Planning Commission Regular Meeting
Tuesday, September 3, 2024 7:00 PM

CITY OF HICKMAN
STAFF REPORT FOR PLANNING COMMISSION
SEPTEMBER 3, 2024 MEETING

ETMUND ESTATES 2ND ADDITION PRELIMINARY PLAT

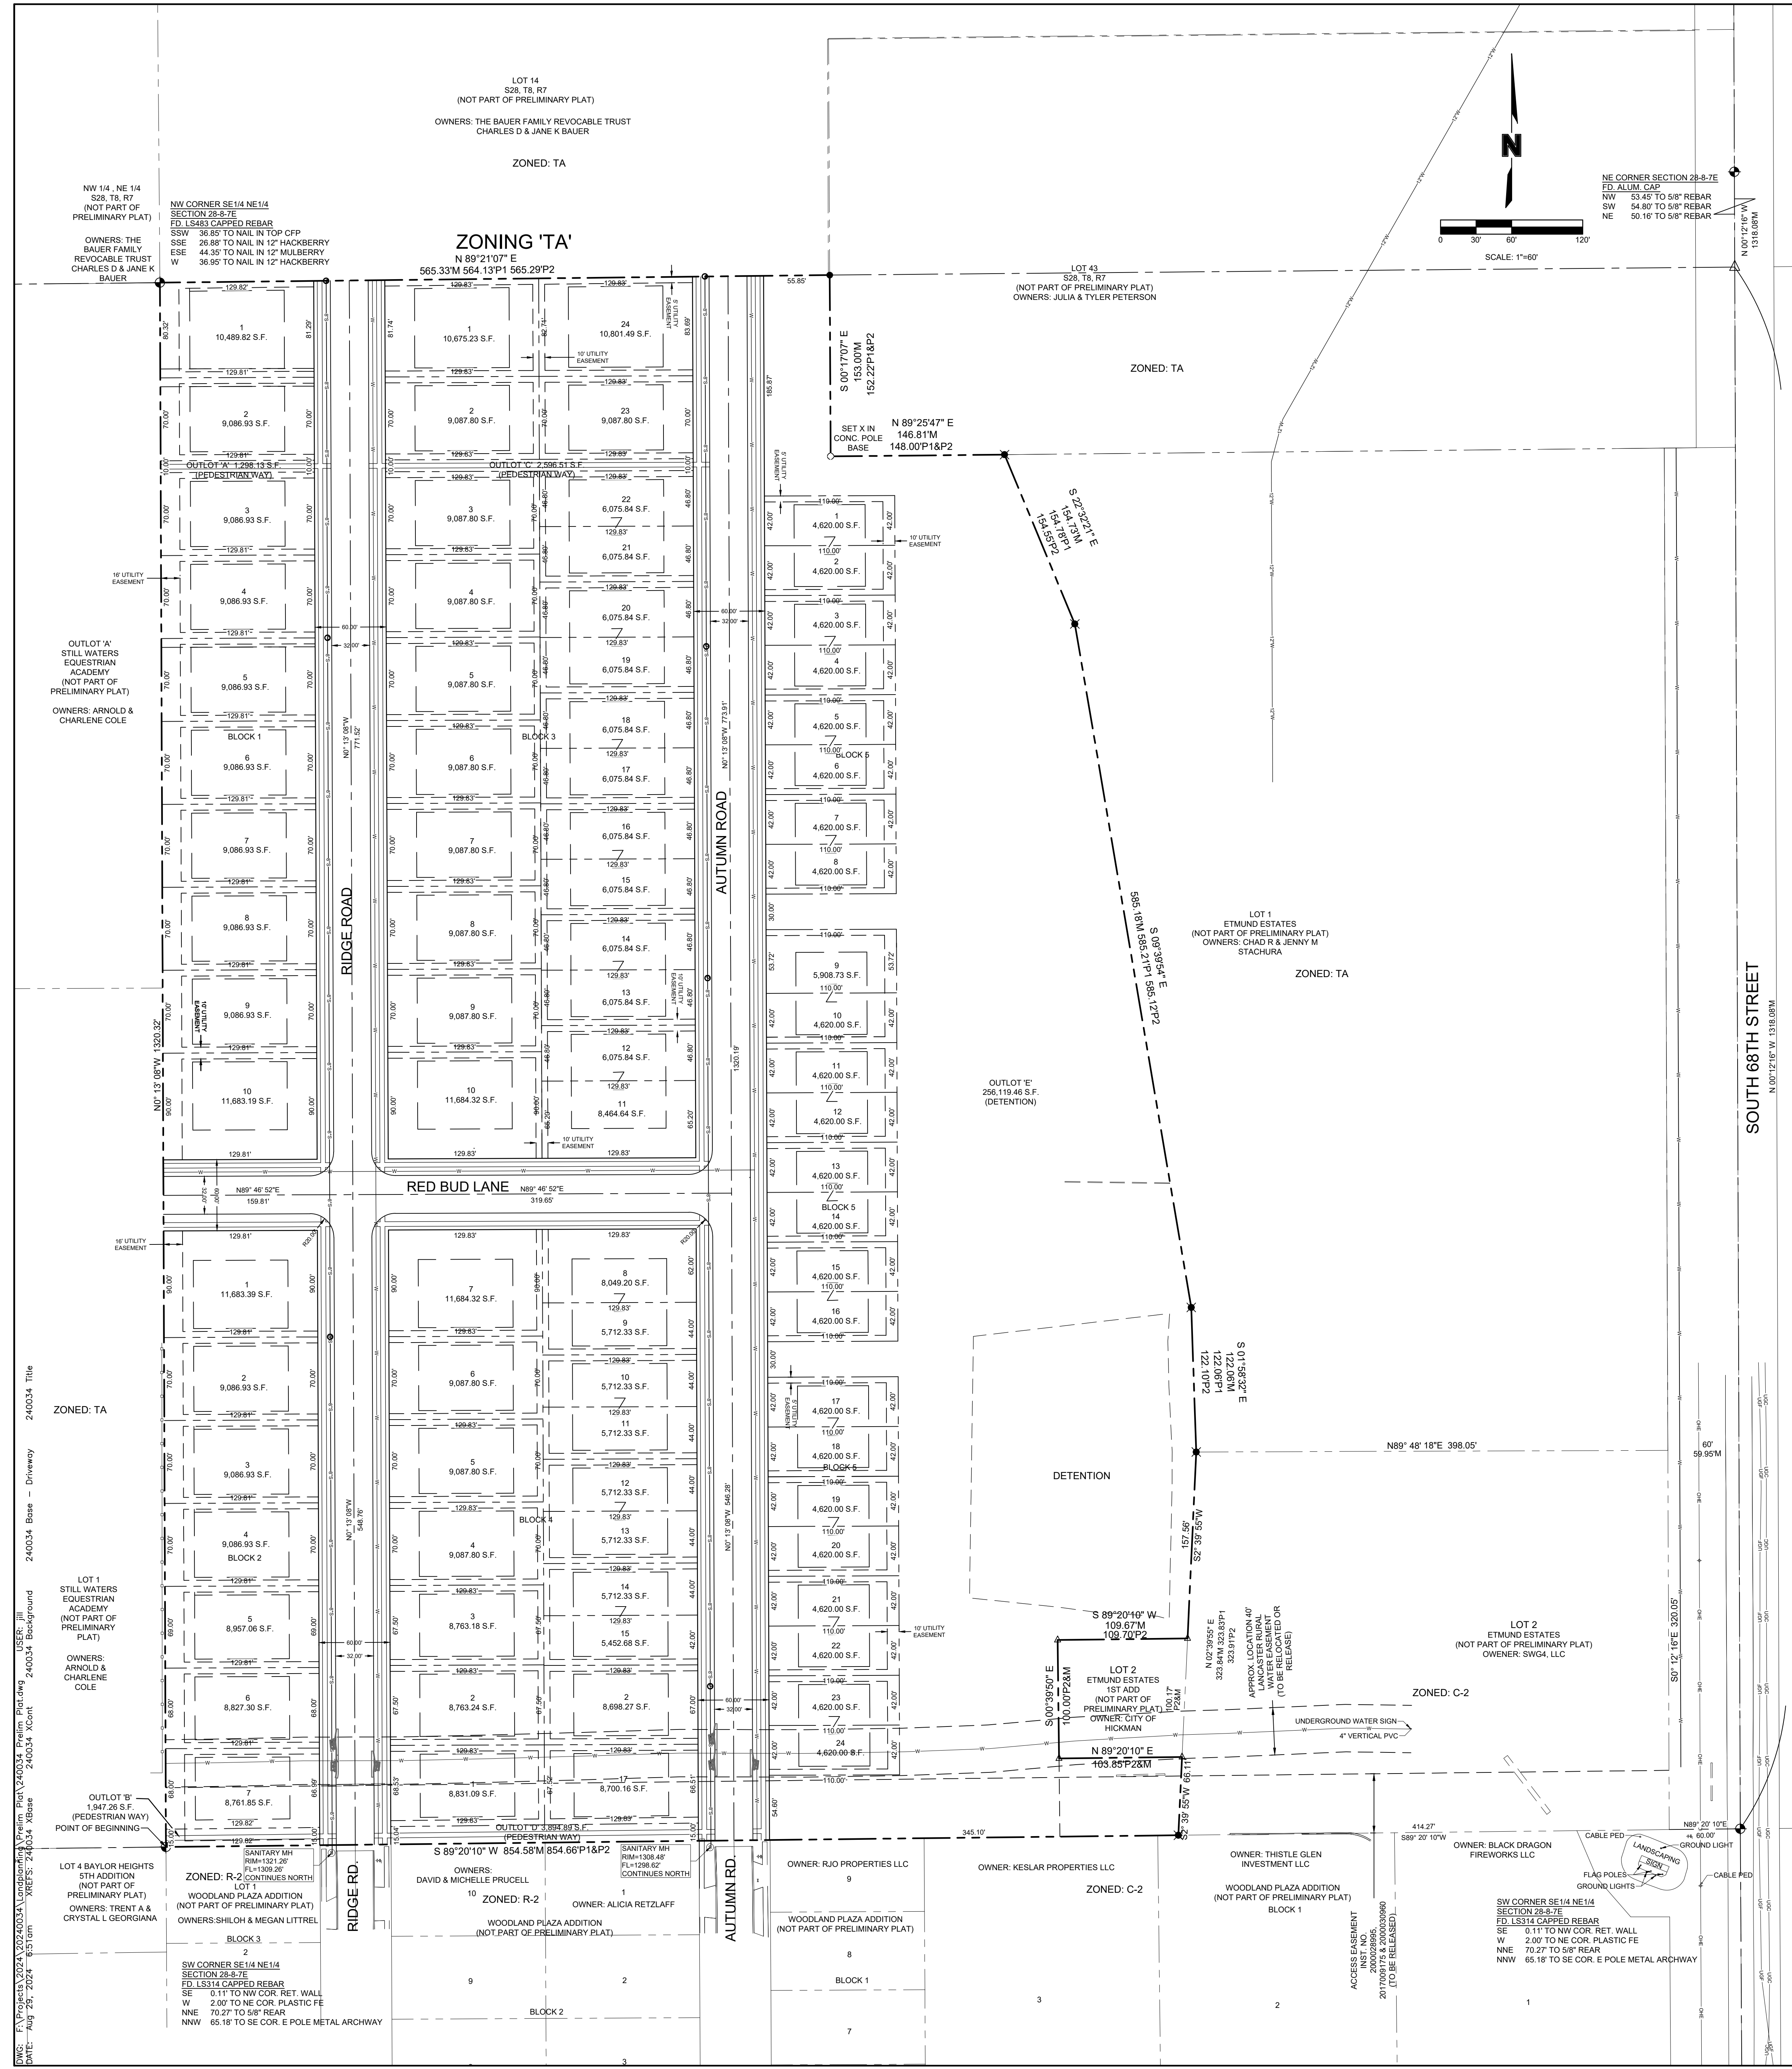
7. *On Page 1, on the north boundary line, symbols for sanitary manholes appear to be shown, add a label in the legend.*

SHEET
2 OF 7

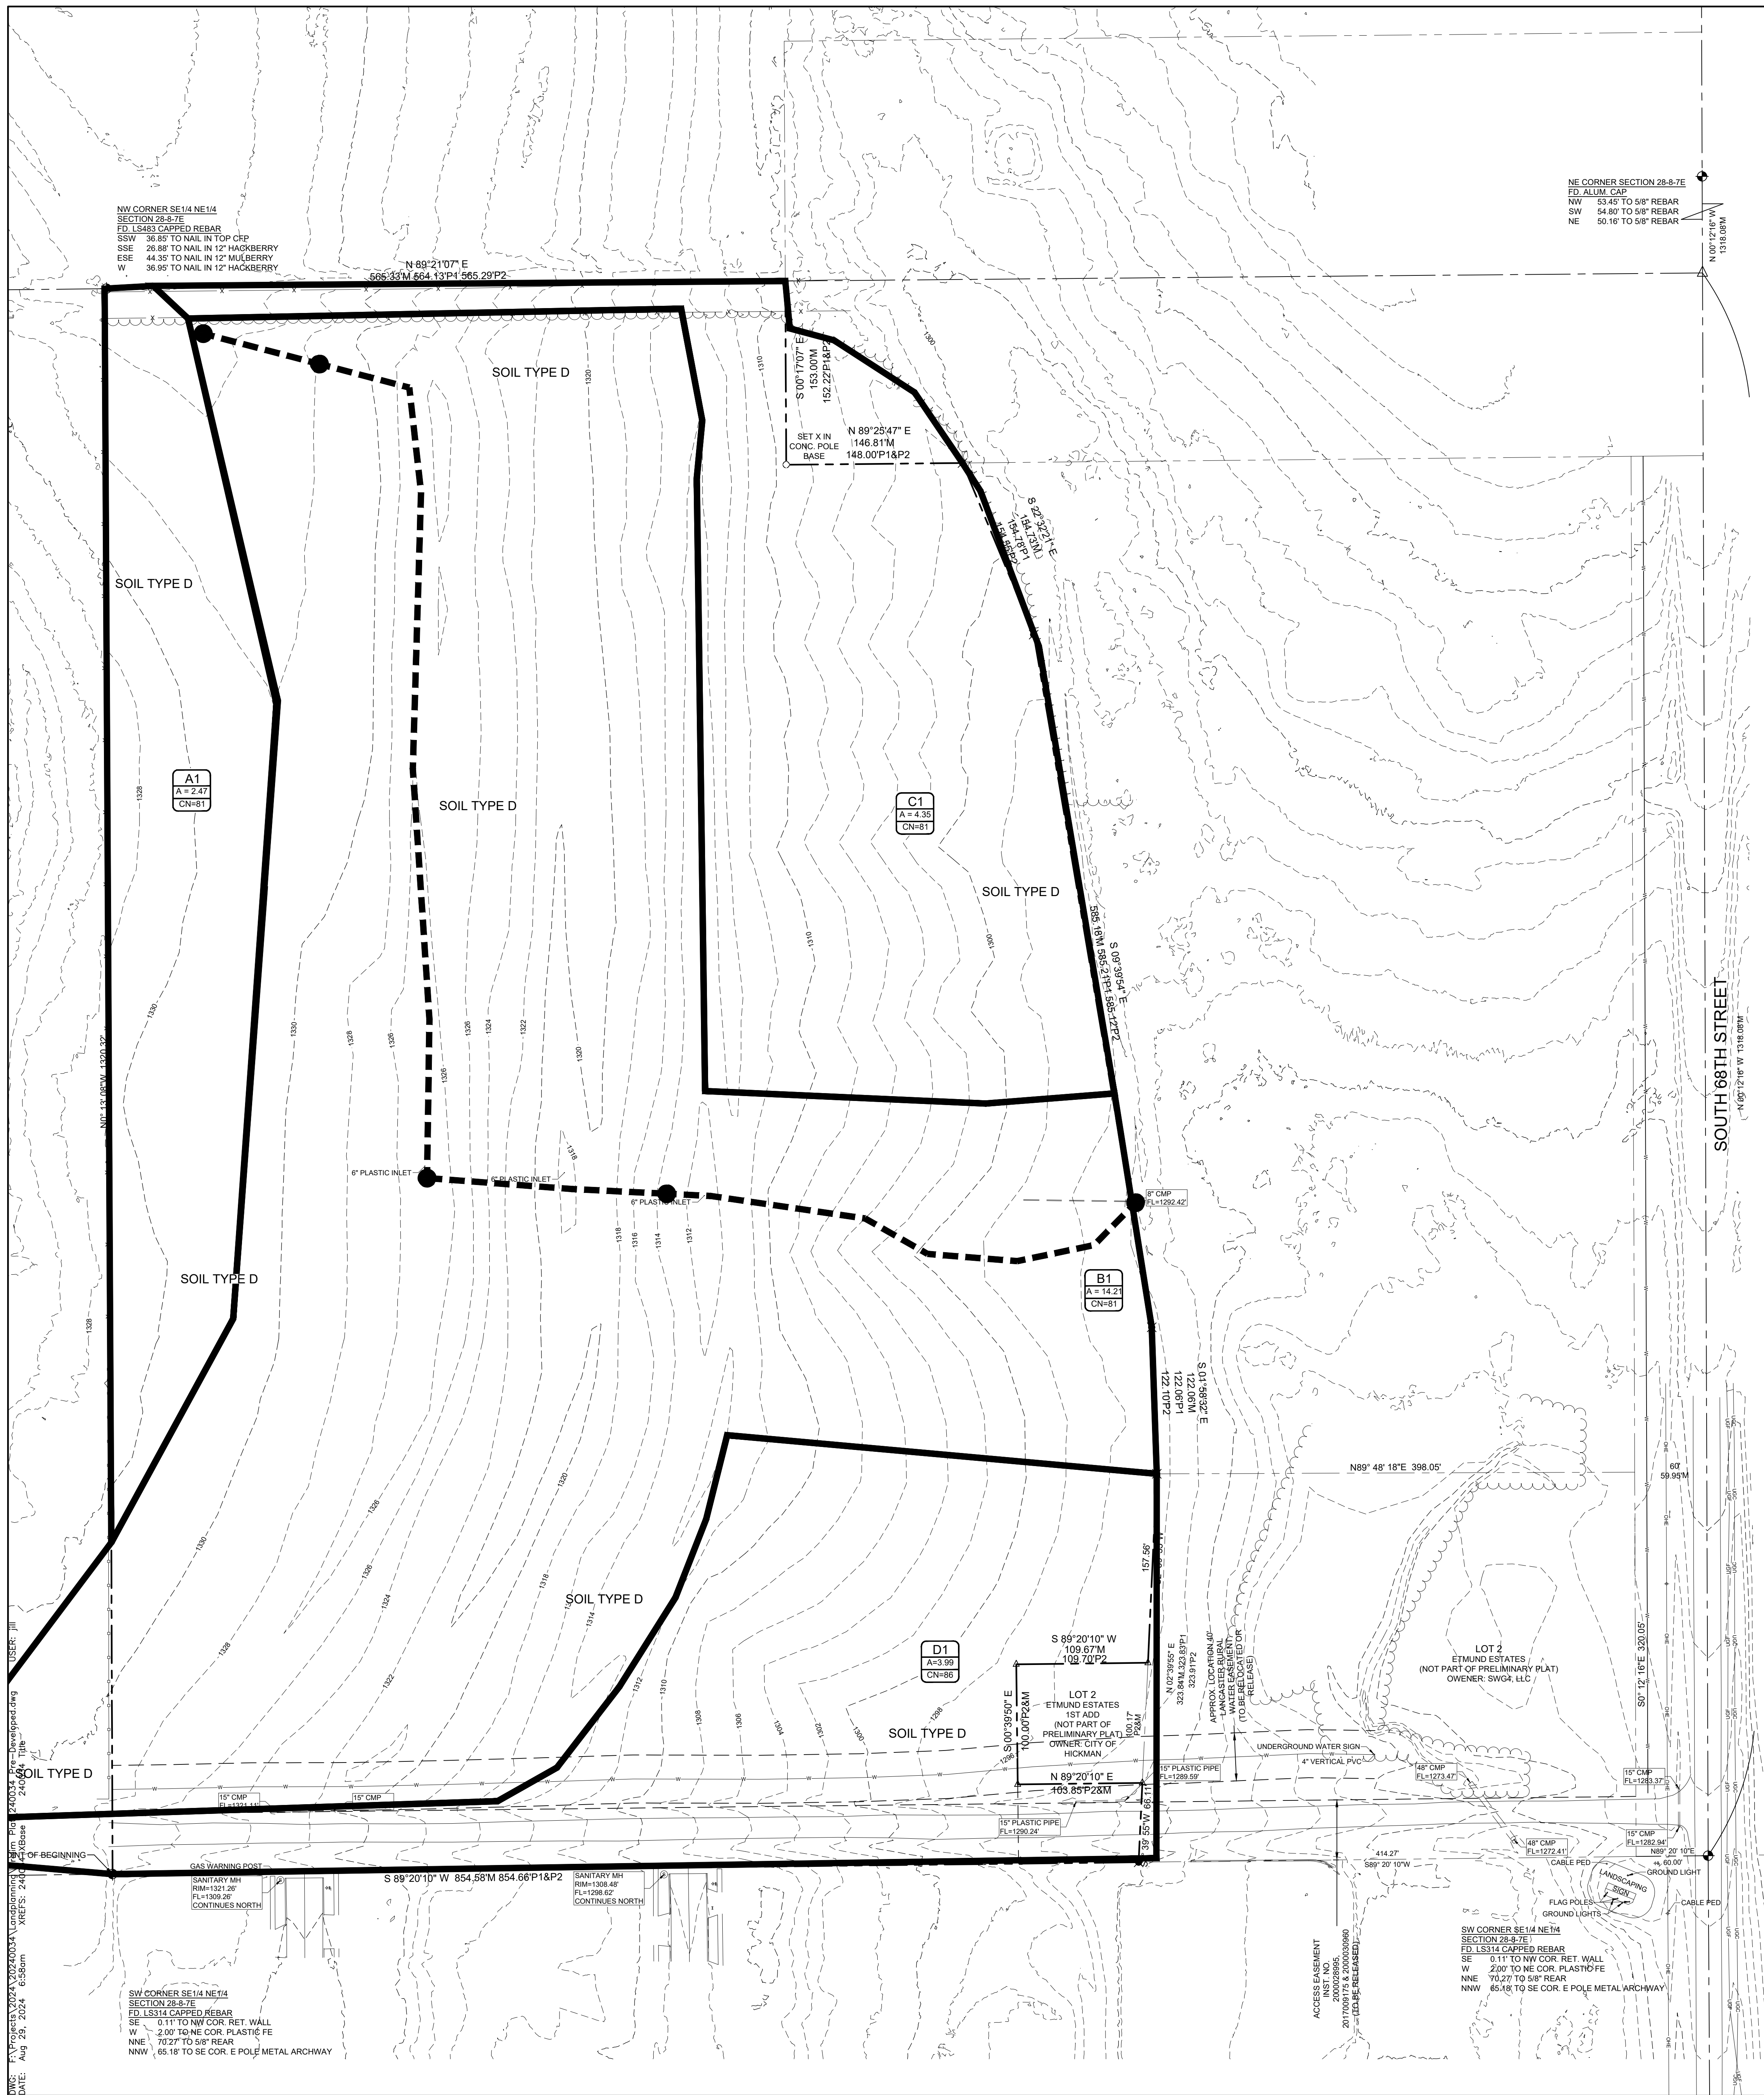
6. *On Page 2, at the southeast corner of the plat, on South 68th Street, a section corner symbol is shown but not labeled. Show a description along with ties. (at the same location there appears to be a leader that goes northerly without any dimension)*

SHEET
 3 OF 7

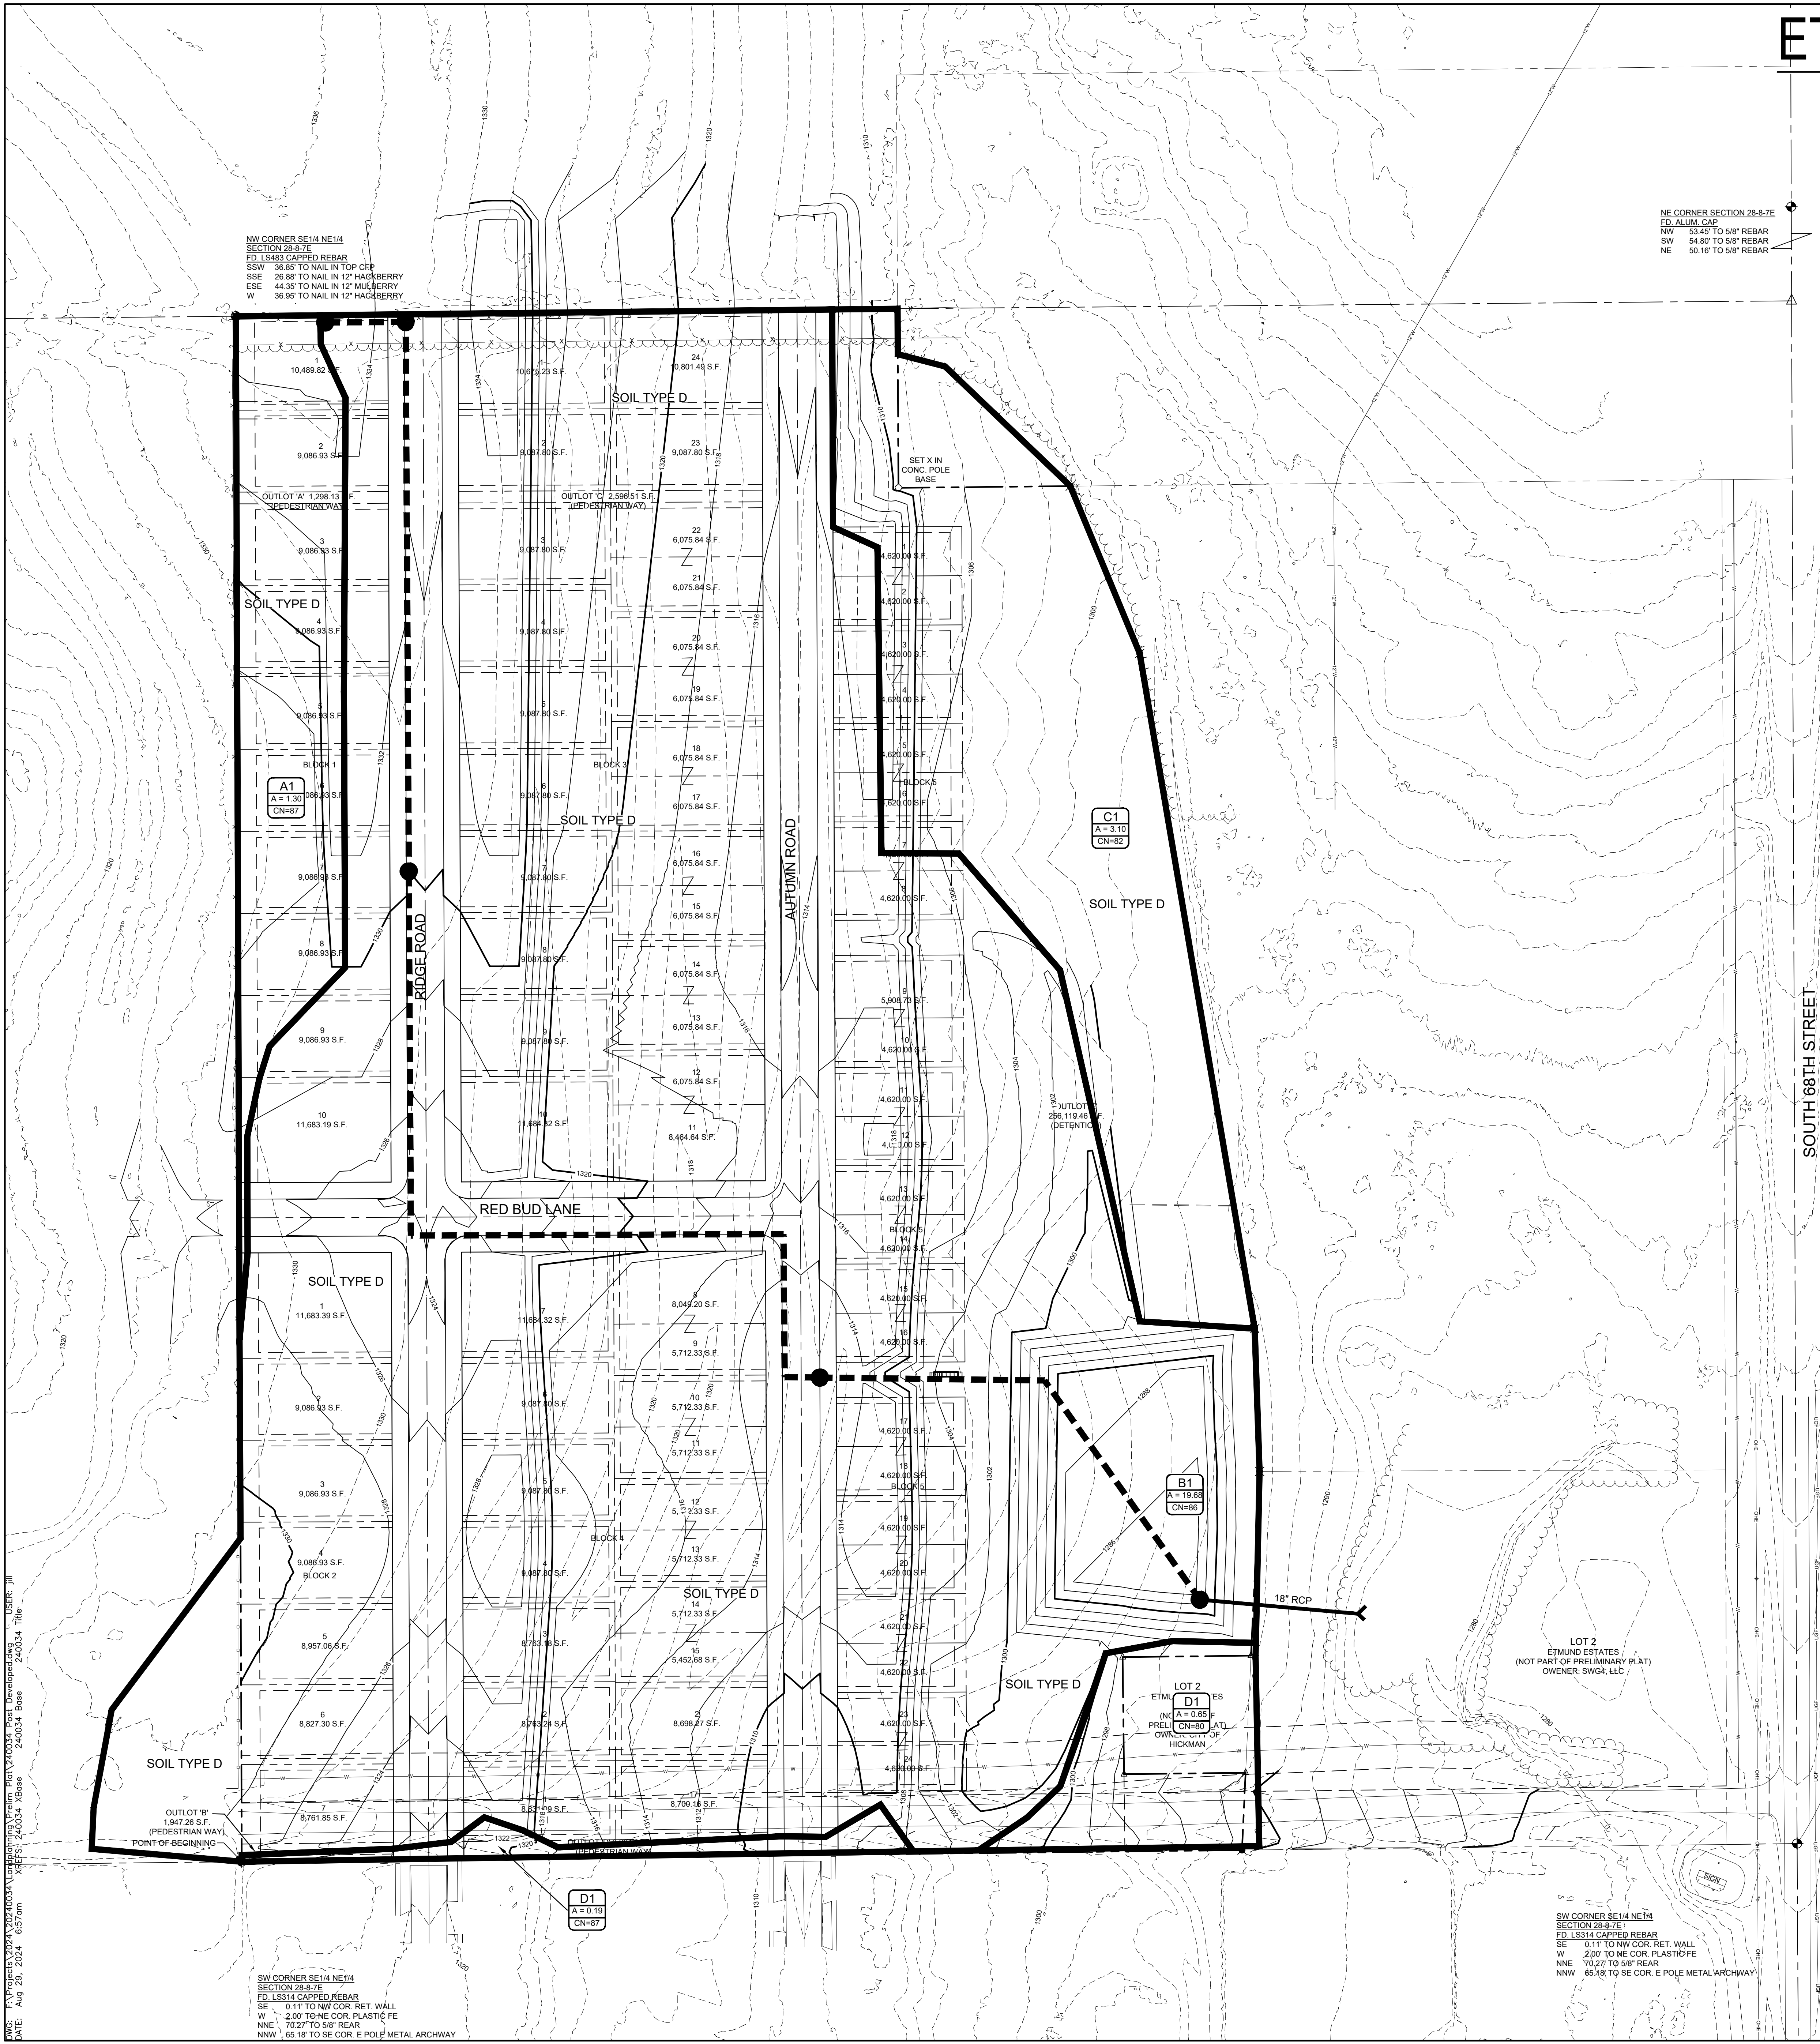
10. *On Sheet 3 of 7 there are two subbasin D callouts for what looks like two different subbasins?*
 11. *In the drainage study, they designed the storm sewer for the 5-year event, but Hickman’s Subdivision Regs call out designing to the 10 year storm. Is this acceptable? if so, the City Attorney’s office may require something in writing saying this is allowable and a comment may need to be added to the General Notes.*
